T10/00-231r0

To: T10 Technical Committee
From: Rob Elliott, Compaq Computer Corporation (Robert.Elliott@compaq.com)
Date: 8 May 2000
Subject: SPI-4 training pattern DC signal strengths

Figure 1. Start of training pattern (SPI-4 revision 0).

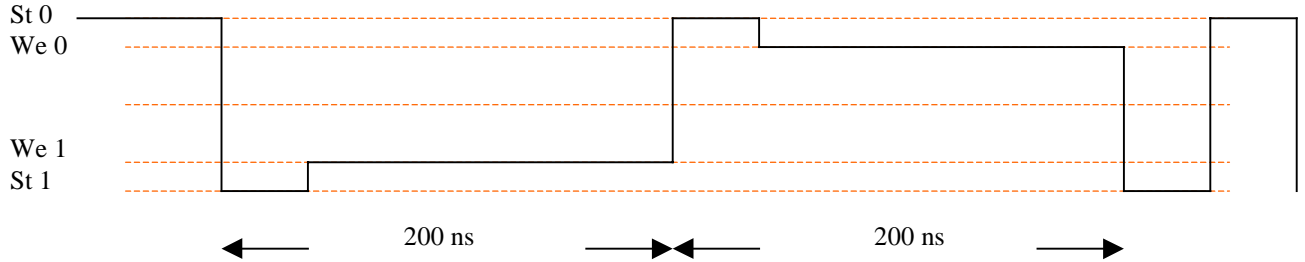
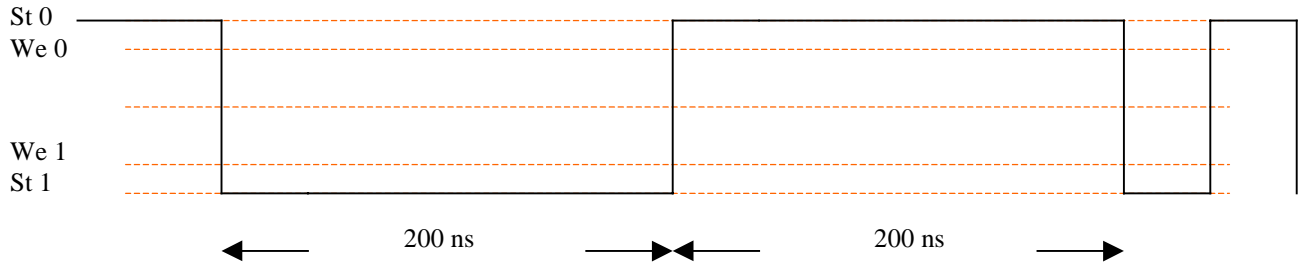
This makes the signal less valuable for AAF (adjustable active filter/aka receive equalizer) training, because it makes the “stable” level less stable and adds an 80 MHz edge, which corresponds to the ideal boost frequency, to the signal.

To eliminate this reason from keeping precompensation and AAF from working together, I propose that precompensation drivers use their strong drive strengths for the initial DC portion, not “cutting back” to the weak drive strength. The precompensation drivers should delay introduction of the weak drive strength until the pauses that follow the 80 MHz section of the training pattern.
